SUBJECT DISPUTE ISSUES FOR THE GROUNDWATER OPERABLE UNIT, WELDON SPRING SITE REMEDIAL ACTION PROJECT, WELDON SPRING, MISSOURI

**RE: Dispute Issues for the Groundwater Operable Unit, Weldon Spring Site Remedial Action Project, Weldon Spring, Missouri**

**DETAILED COMMENTS**  
**Weldon Spring Site Remedial Action Project (WSSRAP)**  
**Groundwater Operable Unit (GWOU)**

Figure 4: Pilot Pump Test Location

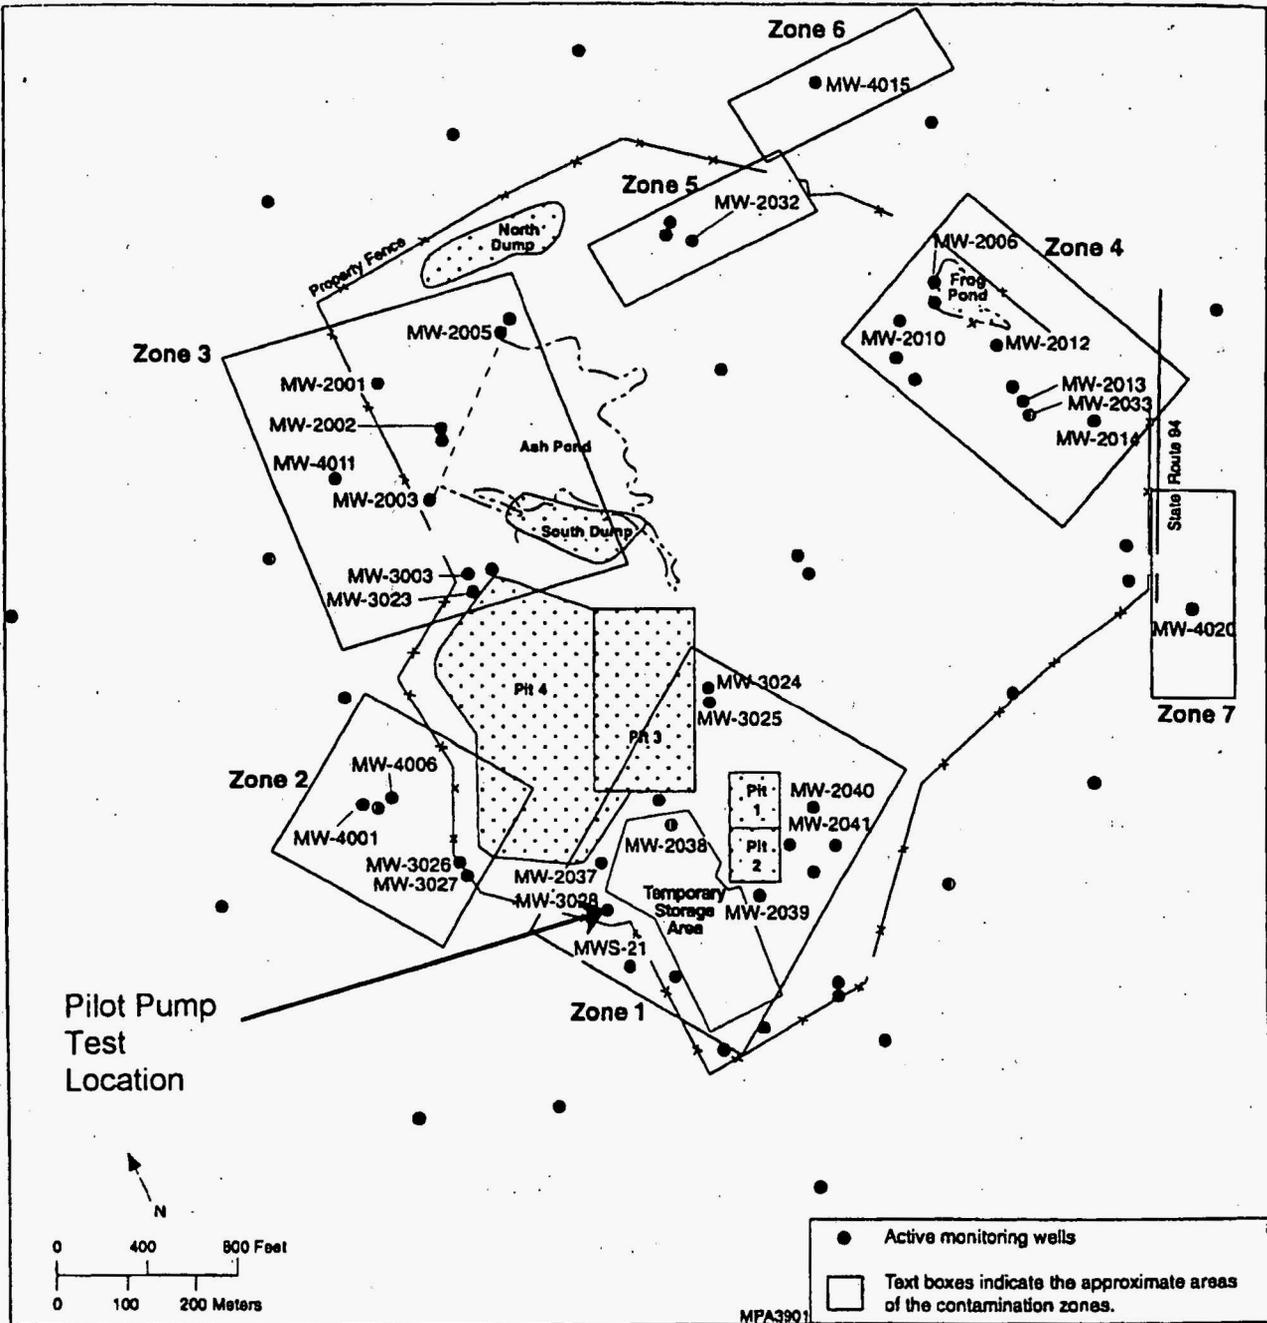
DOE originally developed the pump and treat alternatives (#4 and #7) in the FS that included the possibility of reinjecting treated groundwater back into the aquifer. This option (reinjection) was not developed further due to the large number of injection wells required and the low hydraulic conductivity thought to exist throughout the site (page 3-12, Ref. 2). Since the release of this FS, DOE has performed a field test to collect hydrogeological data in the area of Contaminant Zone #1, (Figure 4). This field test, a Pilot Pump Test was completed in August 1998.

The new data from the Pilot Pump Test was compiled in a completion report (Completion Report for the Pilot Pump Test) which concluded that the transmissivity of Zone #1 was much greater than expected and that sustainable extraction rate exceeded previous expectations. Transmissivity is defined as the rate a fluid is transmitted through a unit width of porous media while under the influence of a unit hydraulic gradient. In the area of MW-3028 the transmissivity of the aquifer was over 700 times more than previously measured prior to the Pilot Pumping Test (p. 51, Ref 3). Table 1 shows the measured transmissivity for the area of concern.

Figure 5: Remediation Times for Contaminant Zone #1 Based on 10 gpm Extraction Rate and a Range of Pore Volume Removal

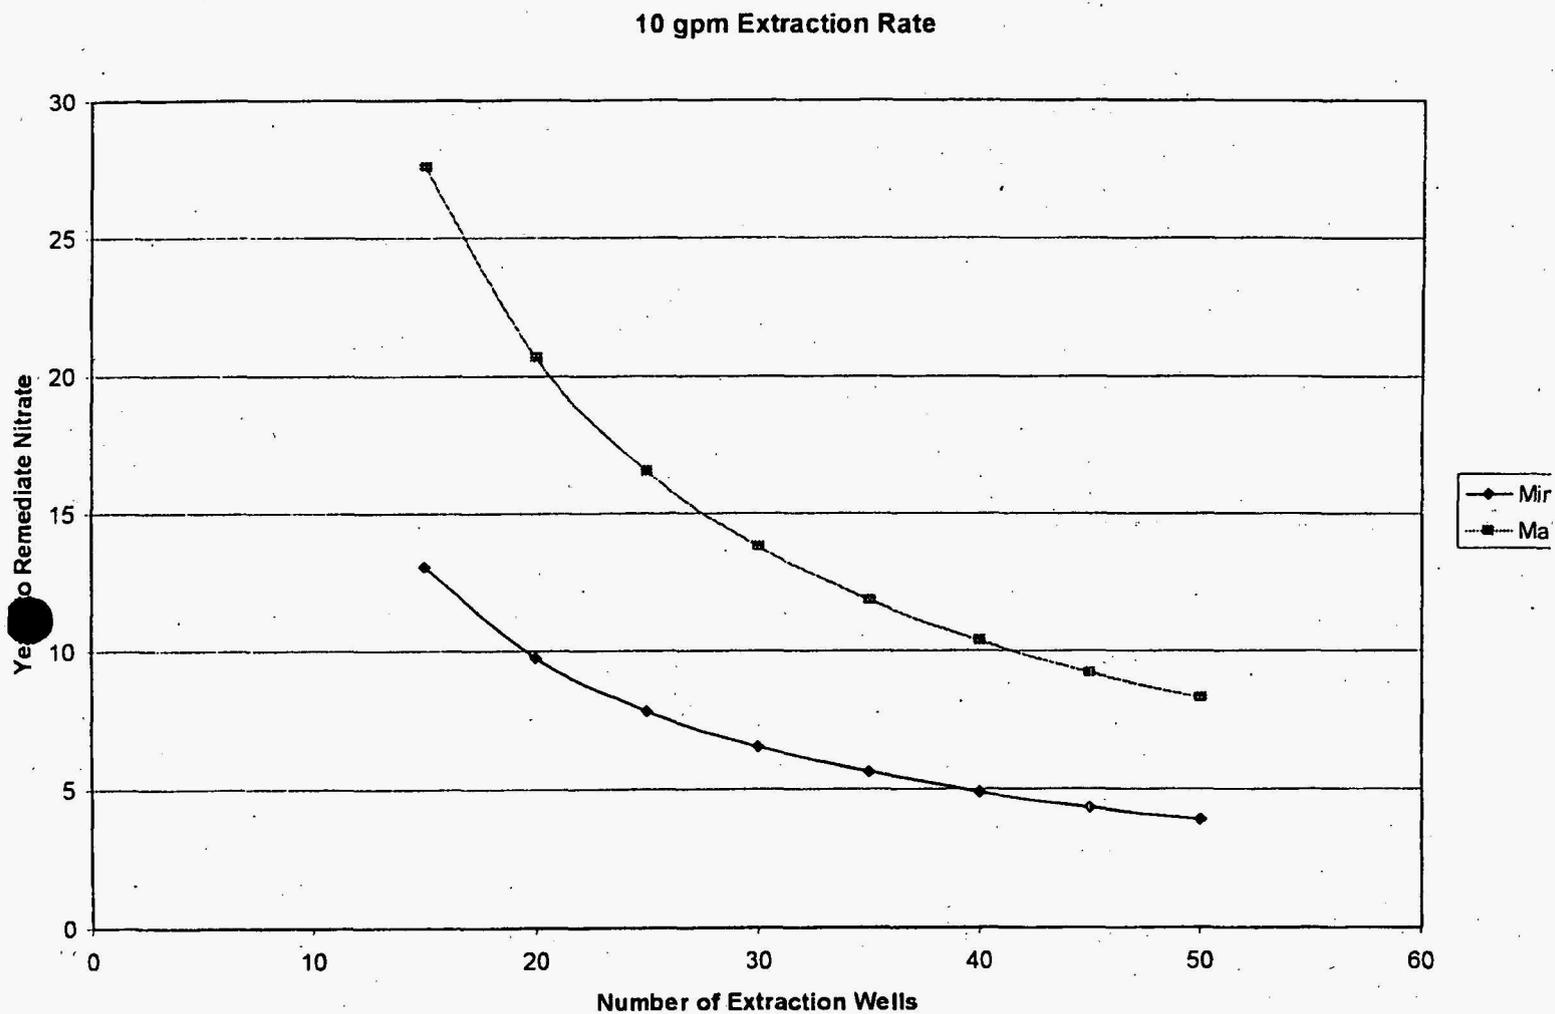
A) The minimal number of wells needed to contain the zone of contamination was used to calculate remediation times. This would equate to a conservatively long remediation time. The optimal number of wells to remediate a zone of contamination would provide for remediation of certain zones in a reasonable time period and a period of time that can be planned for (Figure 5).
